**CITY OF FLORENCE
PLANNING COMMISSION**

RESOLUTION PC 20 13 DR 01 & PC 20 14 DR 02

A REQUEST FOR DESIGN REVIEW OF A DRIVE- THRU COFFE KIOSK AND DRIVE-THRU CARWASH ON TWO ADJOINING LOTS WITH SHARED LANDSCAPING, UTILITIES, PARKING AND ACCESS EAST OF HIGHWAY 101, BETWEEN 5TH AND 6TH STREETS AND WEST OF OLD SCHOOL FURNITURE.

STAFF REPORT & FINDINGS
FLORENCE COMMUNITY DEVELOPMENT DEPARTMENT
Planning Commission
Exhibit "A"

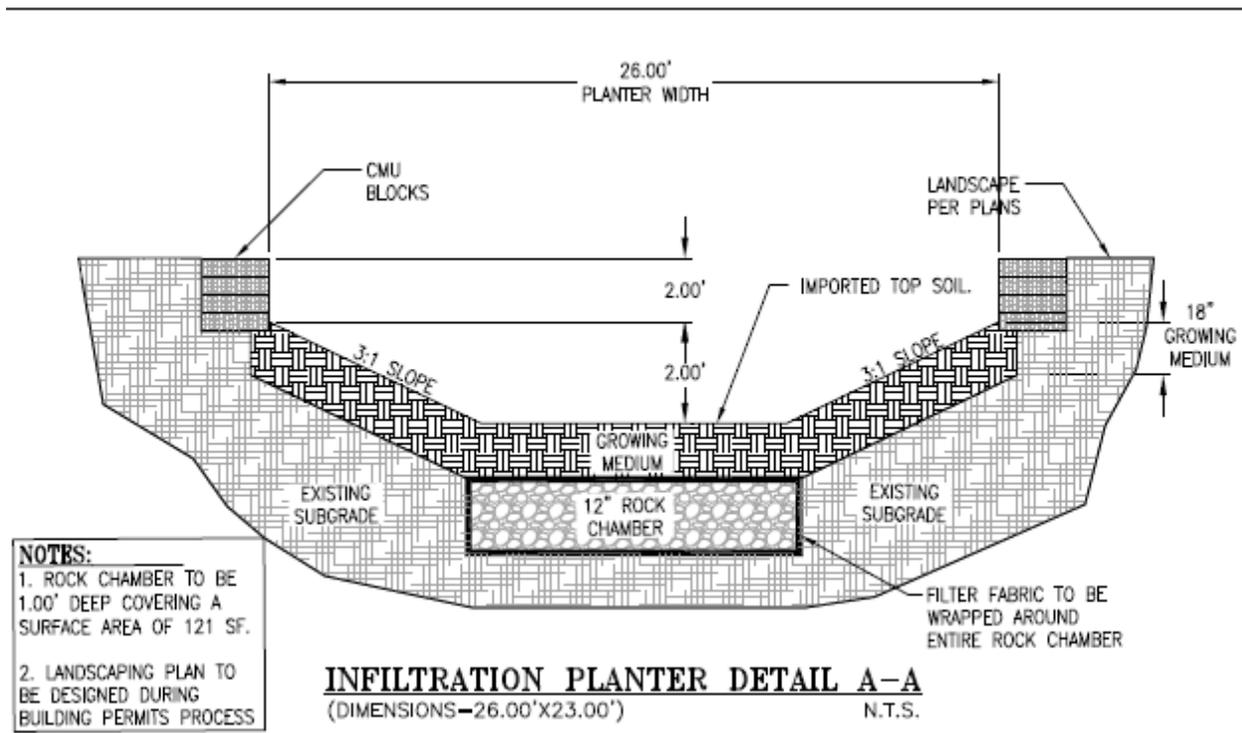
Below is an image excerpt illustrating a stormwater planter design, taken from Sheet C-2 (Utility Plan) in Exhibit D. This sheet is not an option included in the Stormwater Design Manual. The applicant shall either revise the proposal to provide an approved system from the Stormwater Design Manual or apply and receive stamped approval from the Public Works Director for this alternative infiltration planter design, **[Condition 25]**. The proposal also includes catch basins. These catch basin facilities shall also be designed and installed using the approved design in the Stormwater Design Manual. **[Condition 26]**.

24. Lighting shall be extinguished at the end of business hours except as needed for safety.
25. The design of a stormwater planter, taken from Sheet C-2 (Utility Plan) in Exhibit D, is not an option included in the Stormwater Design Manual. The applicant shall either revise the proposal to provide an approved system

from the Stormwater Design Manual or apply and receive stamped approval from the Public Works Director for this alternative infiltration planter design.
